SERVICE BULLETIN ASM-018

Product: Antenna System Monitor

Subject: Firmware 2.70 Release

Date: 9th April 2016

Example of Warning levels of Rx Peak Signal Levels being detected

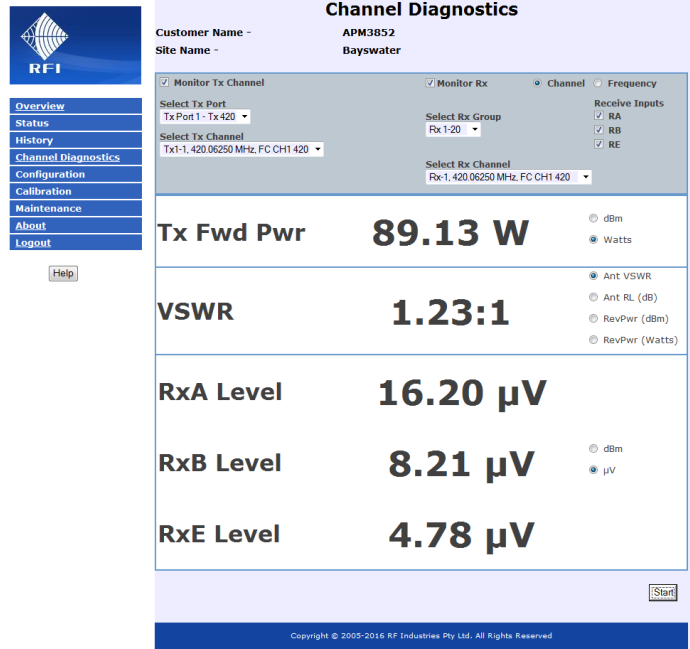
level will be displayed in *Yellow*, and levels above the configured Alarm threshold level will be displayed in *Red*. These Rx peak signal level Alarm Events are also logged and may be viewed in the ASM GUI to assist fault-finding activities.

The RSM also features a unique 'RF Peak Detector' that can measure high levels of RF, even of very short burst duration, that may be overloading the network's base station receivers and degrading network performance.

Alarm thresholds can be configured for these peak received signal levels so that alarm notifications can be actioned.

Acceptable measured levels will be displayed in *Green*. Levels above the configured Warning threshold

Channel Diagnostics

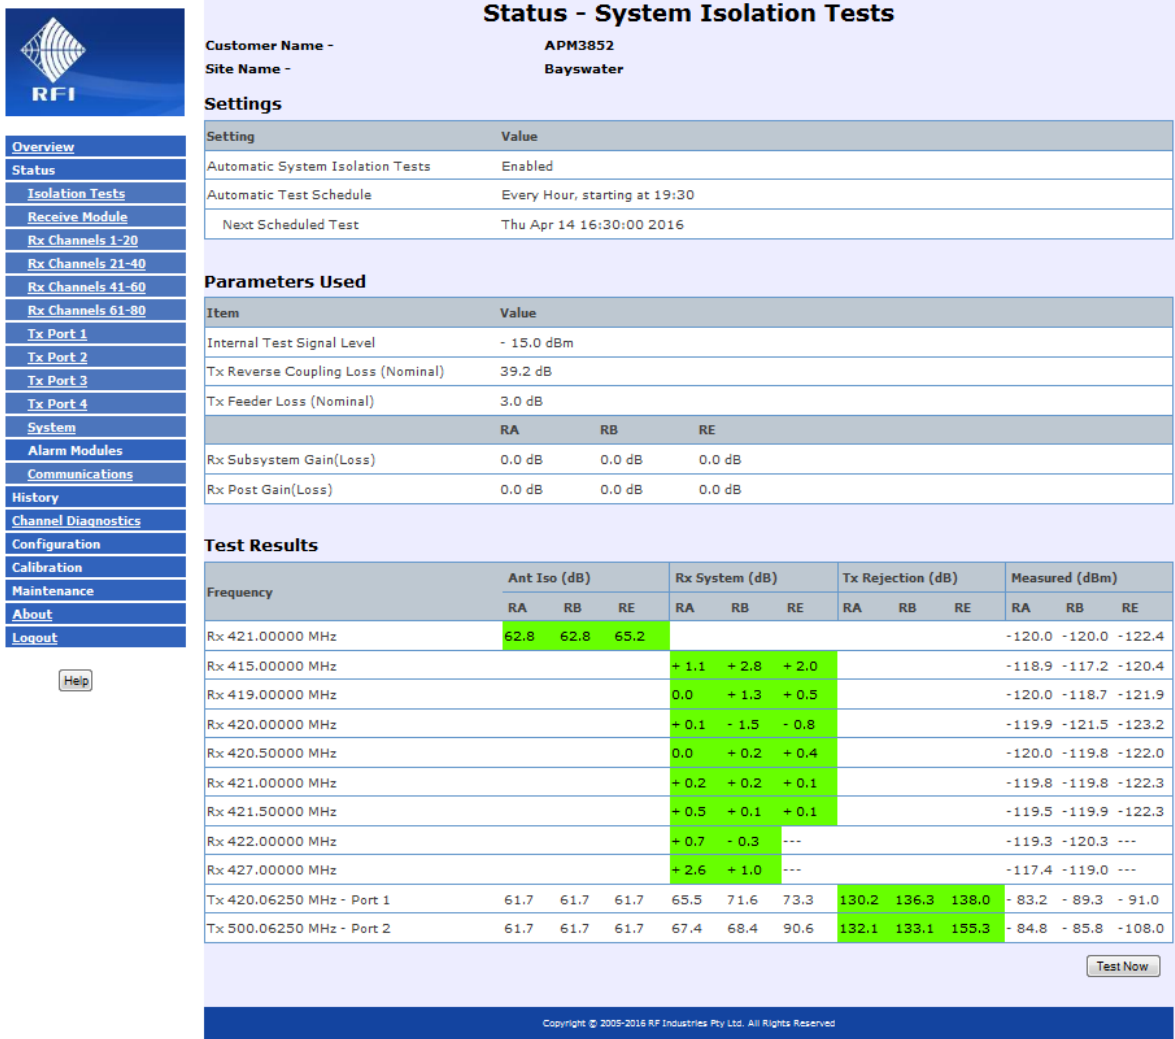
The operation of the Rx monitoring capability of the Service Mode page is enhanced when using the RSM.

The ASM's Rx sensitivity is improved, and the RxA, RxB and RxE receive signal paths can now be individually selected and displayed as desired.
